Access Compliance Report Public Rights-of-Way (Curb Ramps)

Intersection ID: 10020591Main Street: BASIE_PARK_CTCross Street: N/ALocation:NWADA ID: E0695A66FA7FRamp Type: PerpInitial Pass/Fail: FailOverall Compliance: NoSeverity Score:25

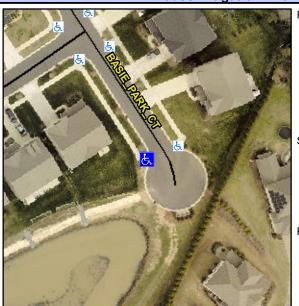
PROW/ADA: N/A
Not Found, R304.2.2, R304.5.3 N/A
N/A
N/A

Fleid Measurements/Component Compnance					
Compliance Description		Data	Compliance Description		Data
N/A	Ramp Length (in)	91.0	No	Ramp Slope (%)	8.6
Yes	Ramp Width (in)	48.0	No	Ramp XSlope (%)	5.1
N/A	Flare Type LT	N/A	N/A	Flare Type RT	N/A
N/A	Flare Slope LT (%)	N/A	N/A	Flare Slope RT (%)	N/A
N/A	Flare Traversable LT?	N/A	N/A	Flare Traversable RT?	N/A
N/A	Landing Length (in)	N/A	N/A	DWS Provided?	N/A
N/A	Landing Width (in)	N/A	N/A	DWS Contrast?	N/A
N/A	Landing Slope (%)	N/A	N/A	DWS Length (in)	N/A
N/A	Landing X Slope (%)	N/A	N/A	DWS Full Width?	N/A
N/A	Landing Curb? (Y/N)	N/A	N/A	DWS Offset (in)	N/A
N/A	Shared Landing?	N/A			
N/A	Gutter Ponding?	N/A	N/A	Gutter Slope (%)	N/A
N/A	Gutter Lip Ht (in)	N/A	N/A	Gutter X Slope (%)	N/A
N/A	Painted X Walk1?	No	N/A	Painted X Walk2?	N/A
	X Walk 1 Direction	To NE		X Walk 2 Direction	N/A
N/A	X Walk 1 Width (in)	N/A	N/A	X Walk 2 Width (in)	N/A
	X Walk 1 Slope (%)	3.1		X Walk 2 Slope (%)	N/A
